## PLANNING AND ZONING CASE CHECKLIST City of Rockwall Planning and Zoning Department

### RIVERROCK TRAILS, PHASE 1A

08/05/2020: Revision 1 Comments - P2020-029; Preliminary Plat for RiverRock Trails, Phase 1A Addition - ETJ Please address the following comments (M= Mandatory Comments; I = Informational Comments)

REVIEWER: TRS

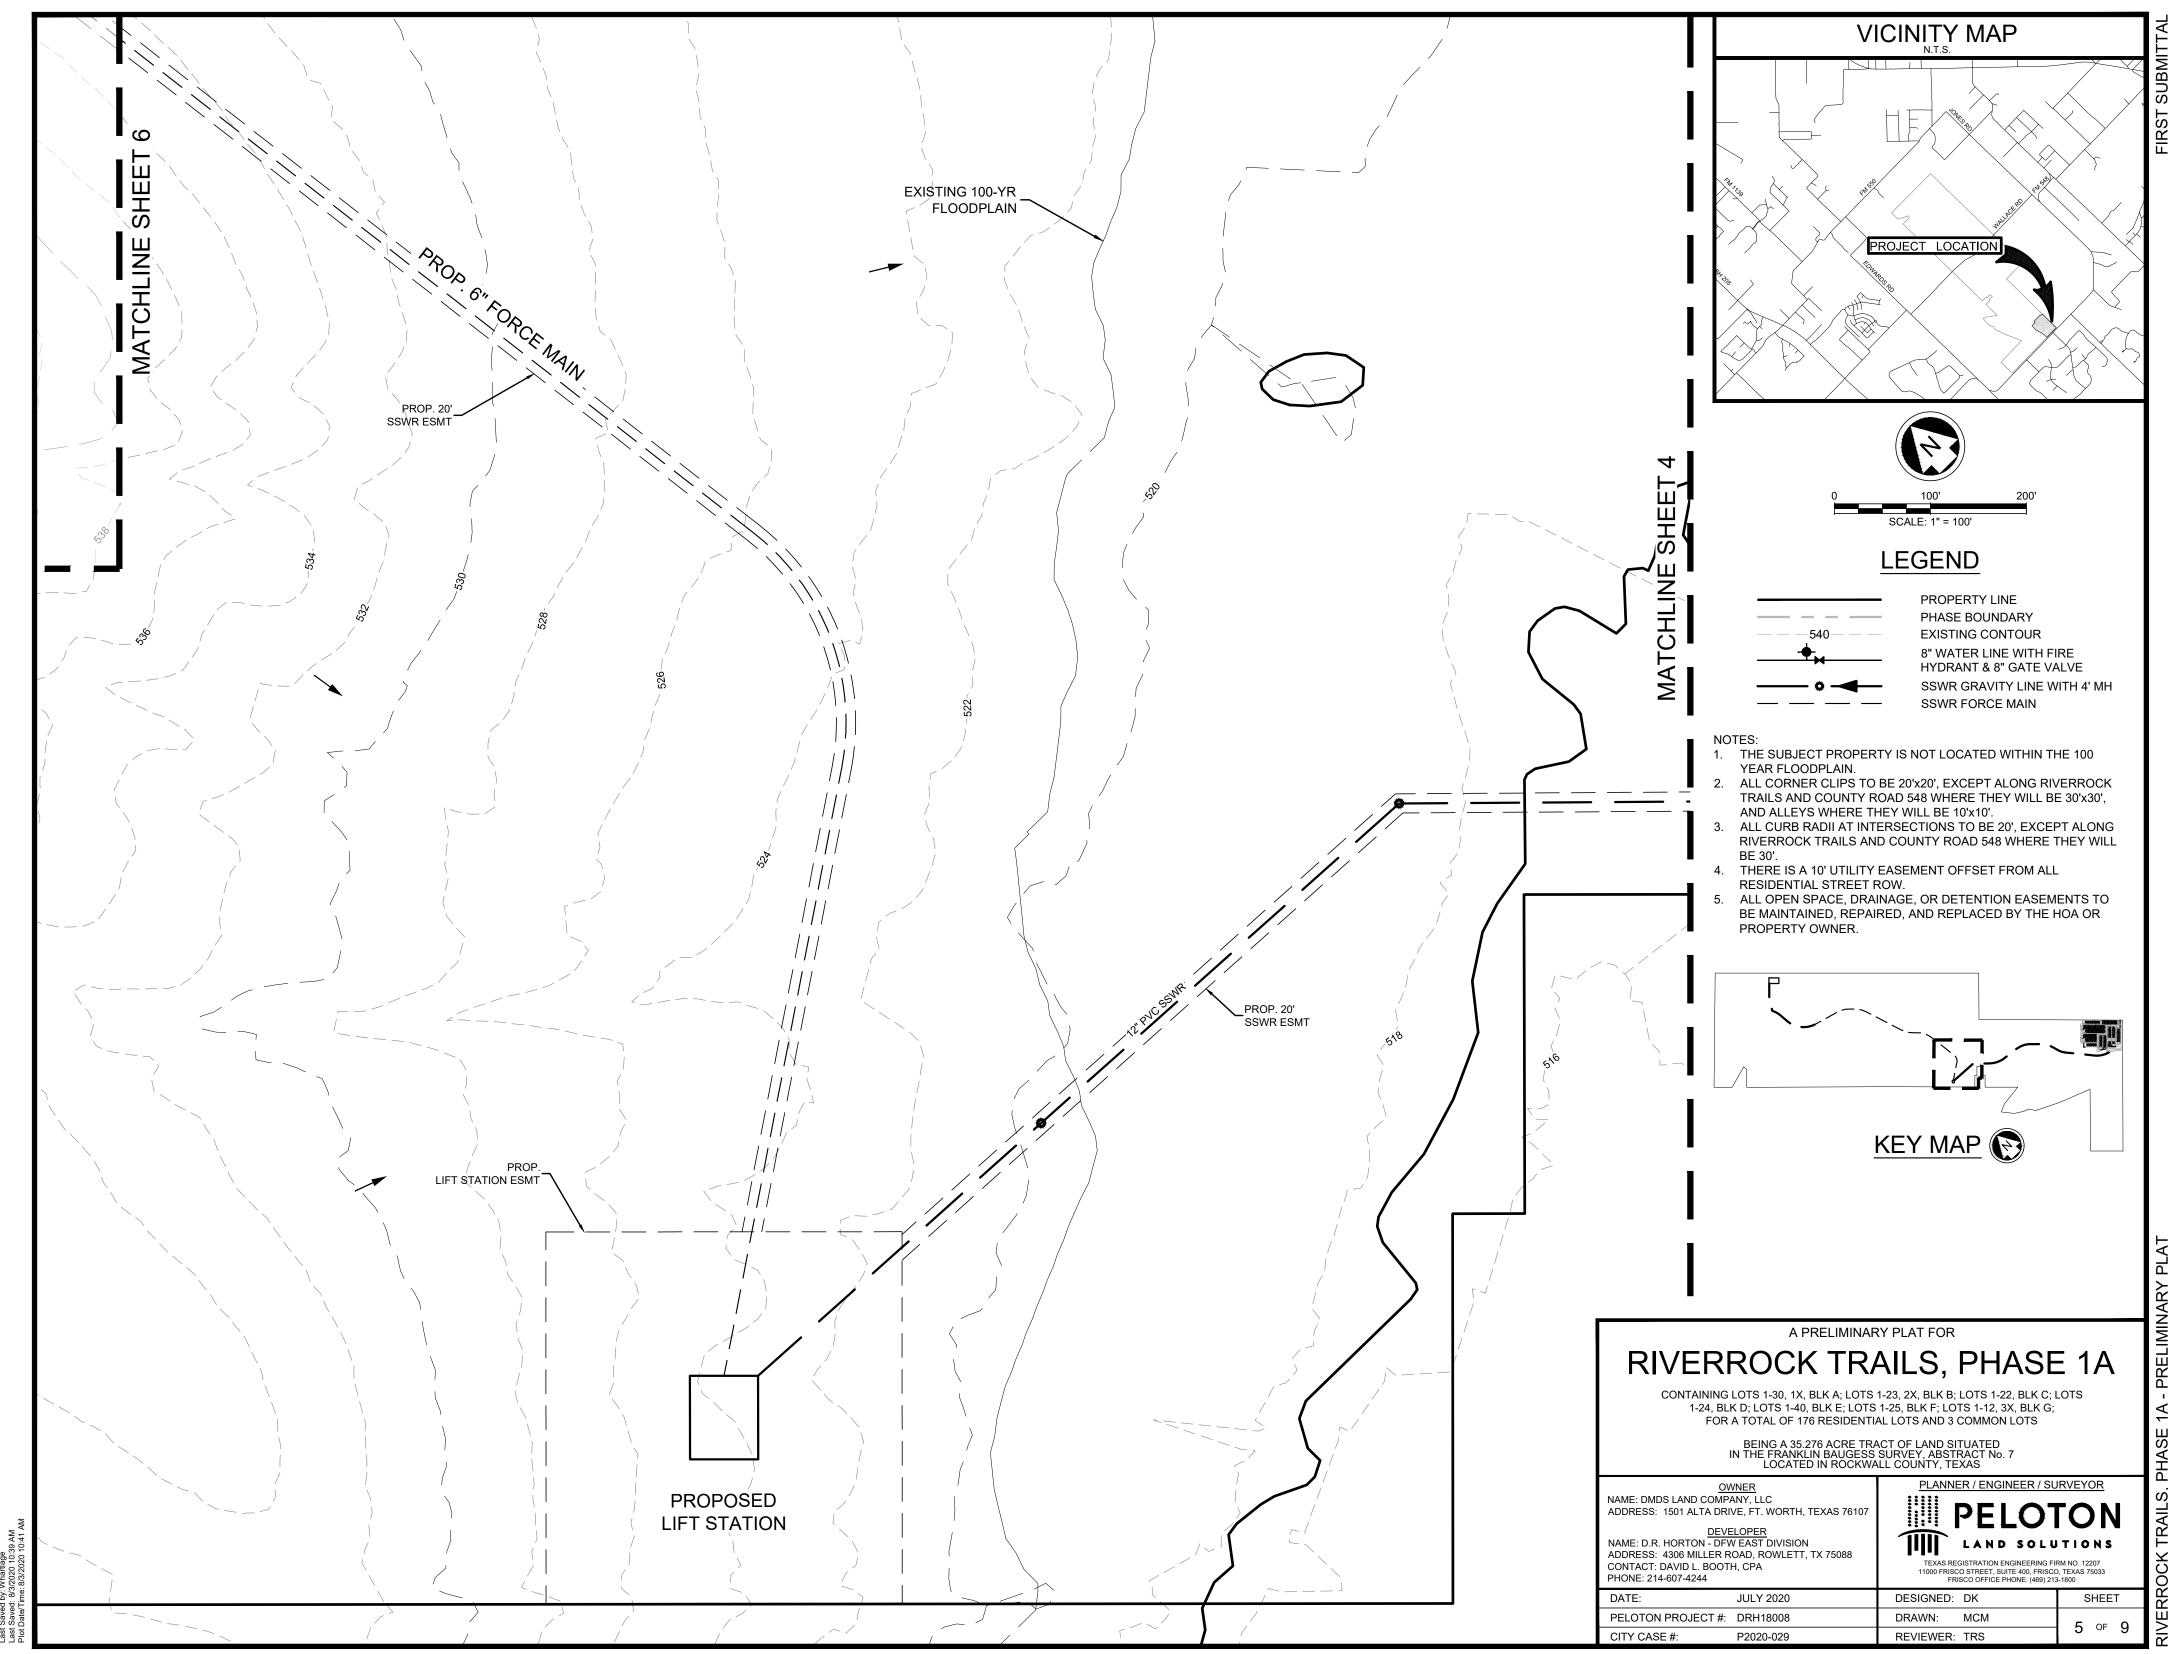
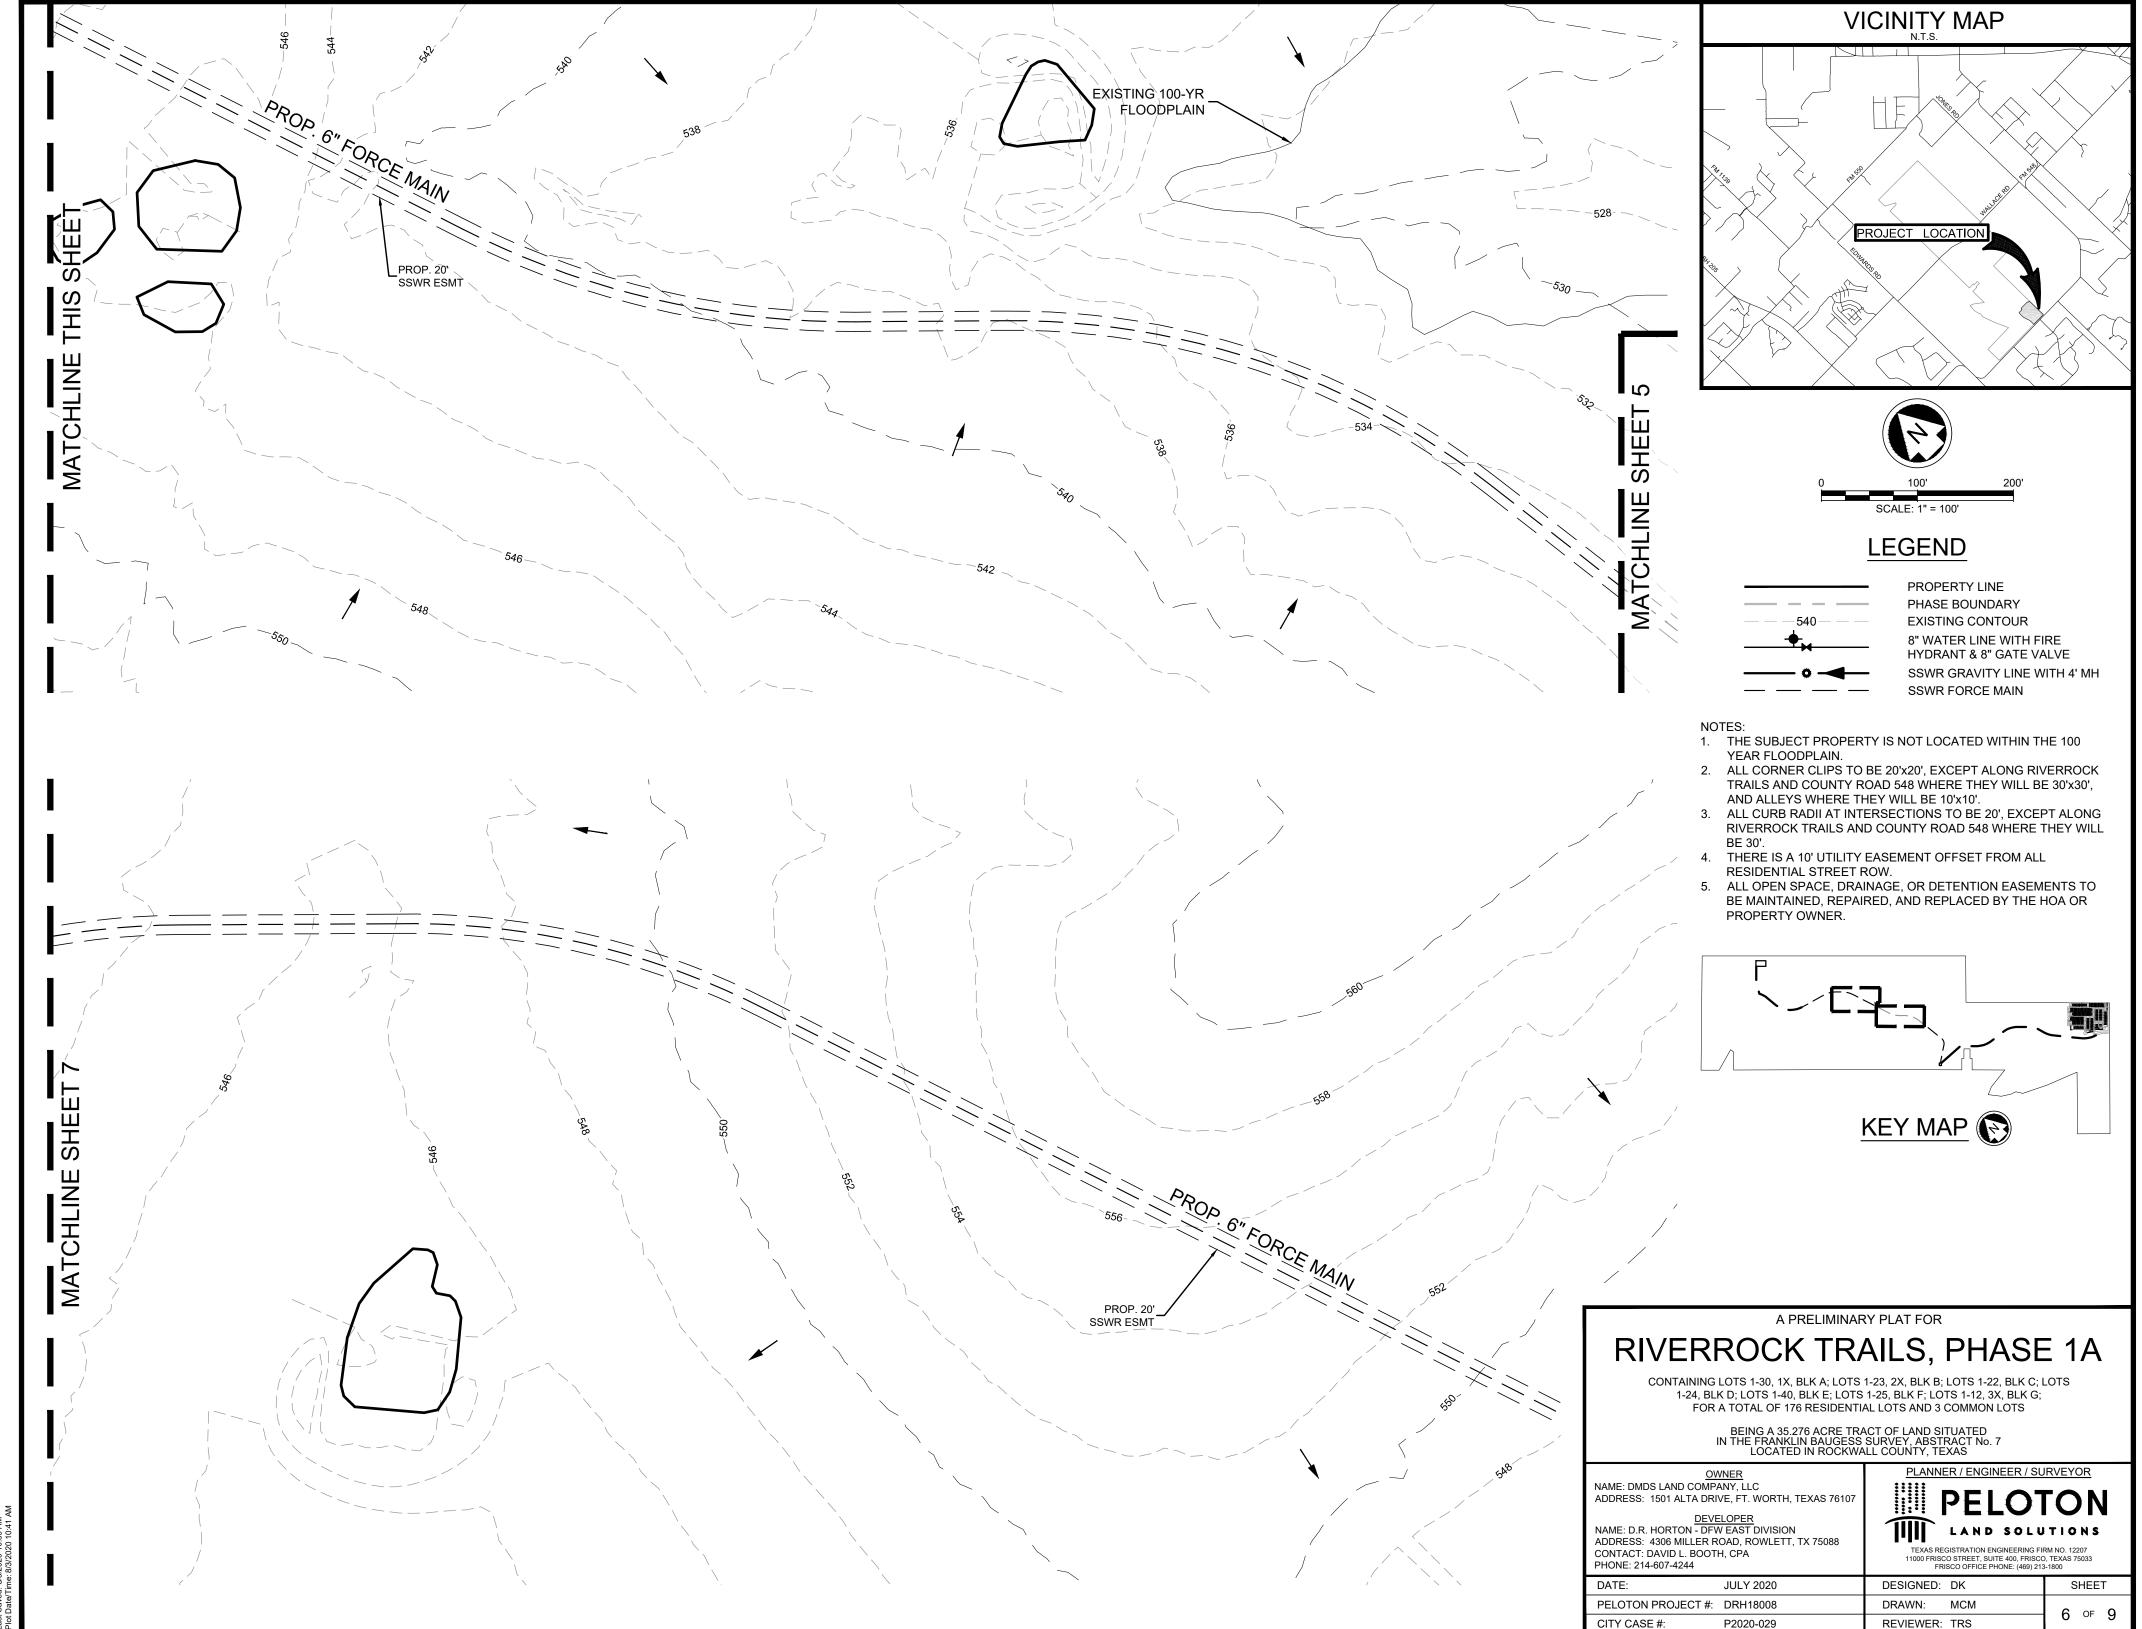
- M.3 Identify the dimensions, names and description of all open spaces, both existing and proposed. Provide labels for the three (3) common areas to indicate "Open Space." (Section 38-8(b)(6)e, Plat Contents, Municipal Code of Ordinances)

- M.4 Please refer to the Checklist for Plat Submittals as found in the Interim Interlocal Cooperative Agreement for Subdivision Regulation (ILA) document and make the following corrections and/or provide a statement for each of the following items. Refer to the language in Exhibit 'A' of the ILA: (Exhibit 'A', ILA)

- a) Provide a detailed statement of how the proposed subdivision will be served by water, wastewater, roadway and drainage facilities that have adequate capacity to serve the development. (Exhibit 'C', ILA)

- b) Provide the appropriate plat wording provided in the application packet that details the designation of the entity responsible for the operation and maintenance of any commonly held property and a waiver releasing the city of such responsibility, a waiver releasing the City for damages in establishment or alteration of grade. (Section (5) (a)(b), Certification and Dedication Language, Exhibit 'A', ILA)
